COMMENT RESPONSE DOCUMENT

EASA PAD No.: 26-093

Published on 31 July 2026 and officially closed for comments on 14 August 2026

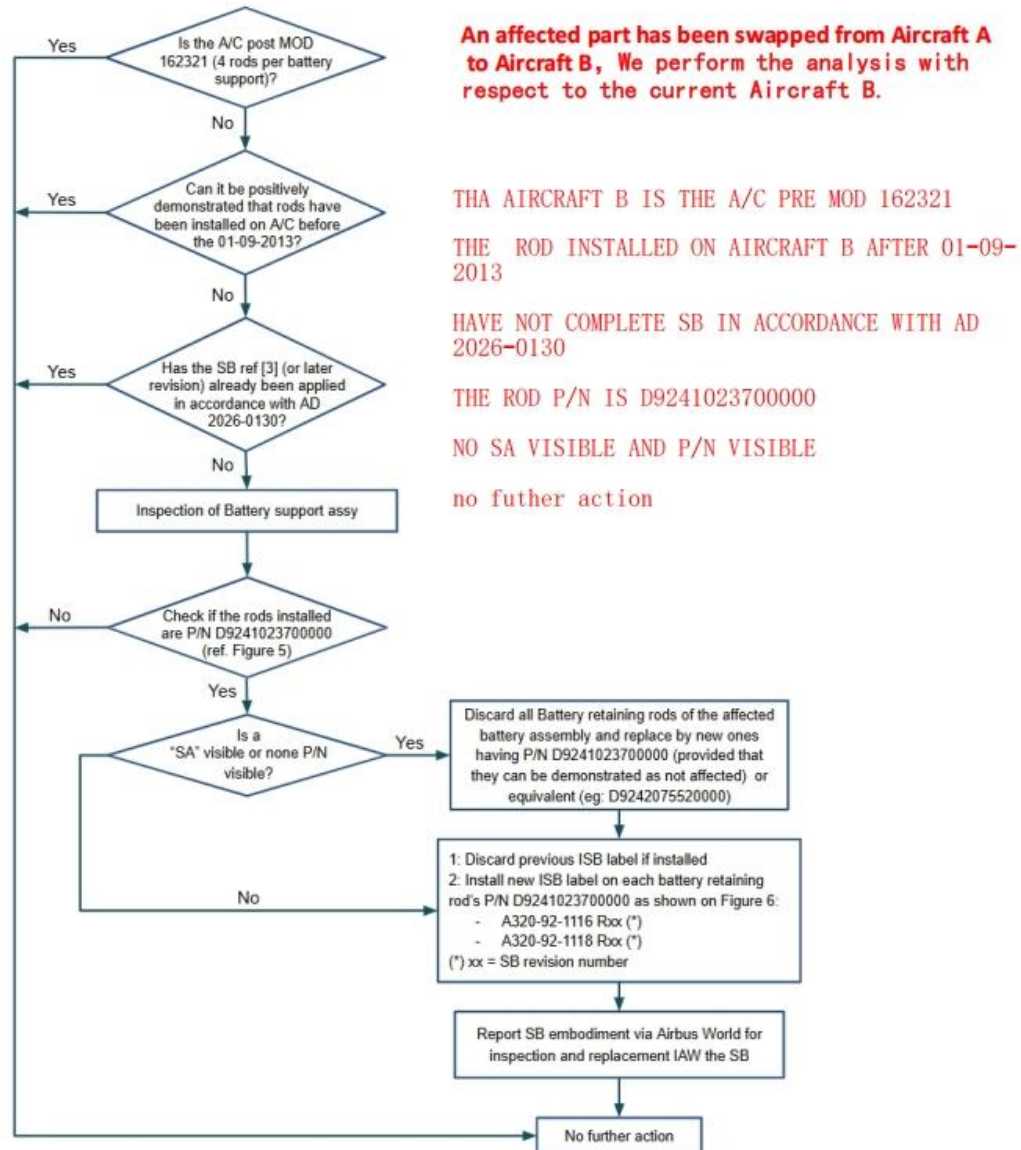
- B. The definition of affected parts within PAD 26-093 is: if no supplier P/N designation is found on the battery support assembly, the battery retaining rods of that battery support assembly are considered as affected parts. However, per SB A320-92-1116R2, assemblies without a part number shall be fitted with a label with no additional actions required, meaning they are defined as non-affected parts.

- C. As no further actions were required for part-number-free assemblies under the prior SB, these assemblies have been categorized as non-affected. Consequently, aircraft installed with these parts are out of our control.

- D. The visual inspection specified in PAD No.: 26-093 is based on AOT A92N001-16. The applicability of this PAD covers the configuration with four retaining rods, whereas all illustrations within AOT A92N001-16 depict the configuration with two retaining rods.

- E. Regarding the concern of roamed-over parts: if an affected part was previously roamed onto an assembly of an aircraft which bears no "SA" quality marking, has a supplier part number and no "SA" marking on the supplier part number, it will still be identified as non-affected upon completion of the current inspection. Therefore, extending the applicability for the purpose of mitigating risks arising from part roaming would not be effective.

EASA response:**Comment noted.****A: Applicability has been updated to include any models having an MSN pre-MOD 162321.****B/C: The AD prevails. To be noted that the new AD is not giving credit to previous AD, and a part identified as not affected per old AD has to be reassessed and confirmed as such.****D: Comment not agreed. The 4-rod configuration is criterion of exclusion as per Group 1 definition.****E: Comment noted. The evaluation was performed considering this possibility as well.****No change has been made to the final AD in response to this comment.****Commenter 16: HK Express – Tian Cheong – 12/08/2026****Comment # 16**
